Inspection Report

Permit Number:	C0150015
Inspection Type:	TECHNICAL
Inspection Date:	Wednesday, October 12, 2011
Start Date/Time:	10/12/2011 9:30:00 AM
End Date/Time:	10/12/2011 4:00:00 PM
Last Inspection:	Wednesday, October 12, 2011

Site: **EMERY DEEP MINE**

Division staff, consultants, Robert Long and Patrick Collins, and mine representatives observed the sites that corresponded to the soils and vegetation data found in Attachment III-1 of the MRP. This report summarizes the planning/action recommended by the Division and discussed with the Permittee and consultants, after observing each site.

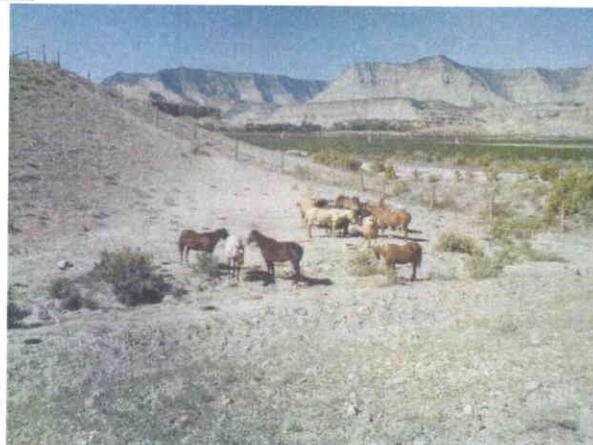
Sites #3 "pond 6 topsoil," Site #4 "pond 6 subsoil East", and Site #5 "subsoil pile West" from pond 6 construction had 0.27%, 11.14%, and 1.38% desirable cover in 2003. At the time of the inspection, all the piles appeared to have less than 1% cover. At the time the site visit, there were 20 head of horses grazing the topsoil and subsoil piles. The management of these piles is documented in Appendix III-1. Grazing on the piles has been historically a problem. The conical shape of the piles also likely has an effect on vegetation establishment. The recommendation action for these three piles is to remove grazing animals by fencing and grade the piles so that they have a lower profile, and are contiguous, but are still contained within the established footprint of the soil storage area. Sites 3 and 4 had very similar chemistry and their boundaries can be blurred. The subsoil west pile, site #5 had higher pH and SAR values and its boundaries should remain distinct. The regraded piles should then be seeded with a revised seed mix that emphasizes the shrubs noted to be successful on other topsoil and subsoil stockpiles: 4-wing saltbush, shadscale, gardner saltbush, mat saltbush, greasewood.

Twenty horses were enclosed within the topsoil/subsoil area.

Horses graze on grasses growing in the low spots. Overgrazing does not allow grasses to produce seed and reduces cover.

Successful reclamation on the Pond #6 Pipeline Road, reclaimed in 1987. This location was not part of the 2003 study.

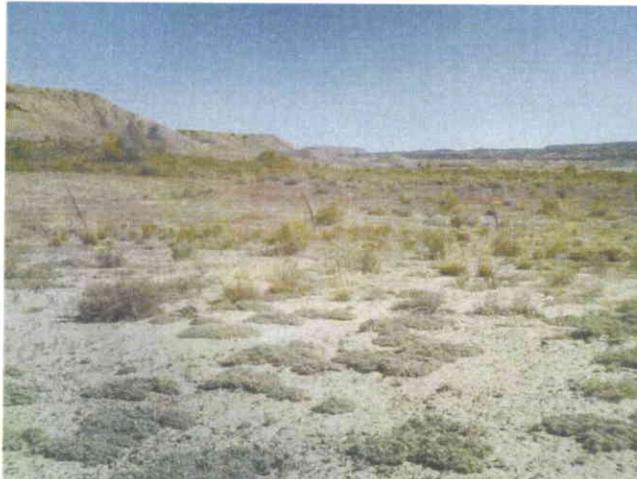
The pond 6 pipeline road was reclaimed in 1987. It was not part of the Appendix III-1 study. According to Steve Behling, it had straw incorporated into the soil with discing and was seeded. The site is marked by roof bolts, but otherwise is undistinguishable from its surroundings. The vegetation is a monoculture of mat saltbush. Some seeded grasses are in low lying areas down wind. All agreed that this site has successfully reclaimed after 24 years. The discing of straw into the soil should be applied to other reclamation sites.

Lastly, we recommended that the final reclamation methodology is revised for all sites, to reflect the successful methods used at the 4th east portal topsoil pile and on the Pond 6 pipeline road. The 4th East portal reclamation treatments included the incorporation of 1T/ac straw with surface roughening and hydroseed and hydromulch with a mixture of cool season grasses as well as shrubs noted to be successful on topsoil and subsoil sites in Appendix III-1 (i.e. 4-wing saltbush, mat saltbush, gardner saltbush, shadscale, greasewood). Irrigation may not be practical, but seeding should be timed for late August to January to take advantage of either the late summer/early fall rains and/ or the early spring snow melt.

Compare the above photo with Site #8, Borehole reclaimed road (2.6% desirable cover in 2003). This site is a half mile east with the same aspect, but gently sloping topography.

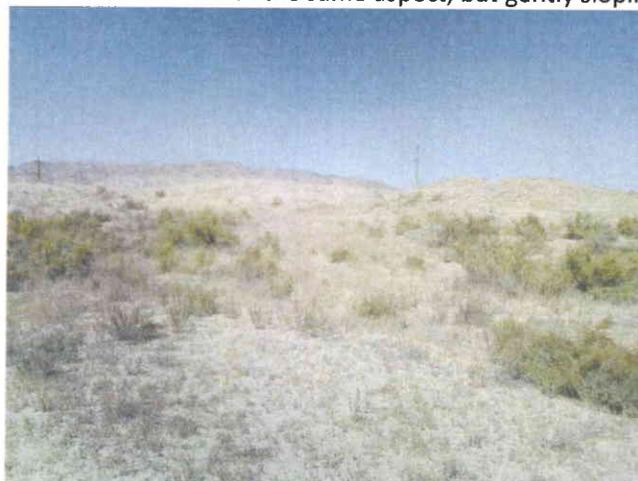
Site #8, the borehole reclaimed road had only 2.6% desirable cover. This road had no topsoil removed and reclamation treatments were limited to seeding. In retrospect, this site might have benefitted from deep ripping, incorporation of straw and hydroseed/mulching methods.
